<b>ADDRESS</b>	5304 WINDWARD PARKWAY		
<b>DISTRICT, LAND LOT</b>	2/2, 1120		
<b>OVERLAY DISTRICT</b>	HIGHWAY 9		
<b>EXISTING ZONING</b>	C-1	<b>ACREAGE</b>	2.324
<b>EXISTING USE</b>	COMMERCIAL/RETAIL		
<b>FUTURE LAND USE DESIGNATION</b>	RETAIL

**REQUESTED VARIANCE(S):**

- To allow light poles to exceed the maximum allowable pole height
- To allow shoe box style lighting fixtures (Article 12G.4.D, 4 & 9)

## **COMMUNITY DEVELOPMENT STAFF ANALYSIS**

# LIGHTING PLAN

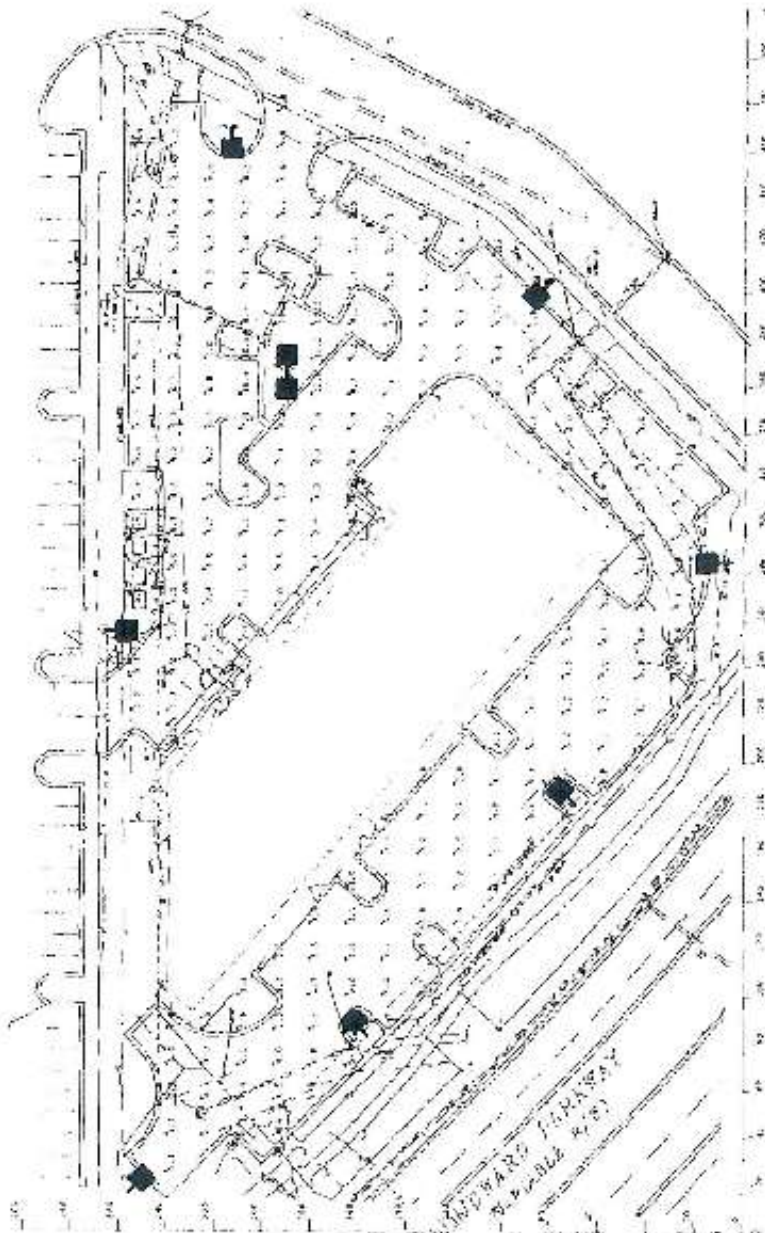
Article 12.G.4.6 states that the entire site must be brought into conformance with this article should a renovation, upgrade, or addition occur that would require a land disturbance permit. The Contractor originally stated that the original fixtures were to be reused. At the January 5<sup>th</sup> Design Review Board (DRB) meeting, he stated that new fixtures were installed. Staff informed the Contractor on several occasions that once the fixtures came down, they would have to conform to the current Ordinance. Article 12G.4.D.4 states that the maximum

mounting height for a pole is 28 feet. According to the order approved by Georgia Power, the height of the poles is 35 feet. Article 12G.4.D.8,9 states that lights shall be architecturally decorative with a historic style...Shoe box, cobra lighting fixture, and neon lighting are prohibited. The fixtures currently installed are of the shoe box style.

At the January 5<sup>th</sup>, DRB meeting, the Board stated that the light poles should match Highway 9 Overlay requirements.
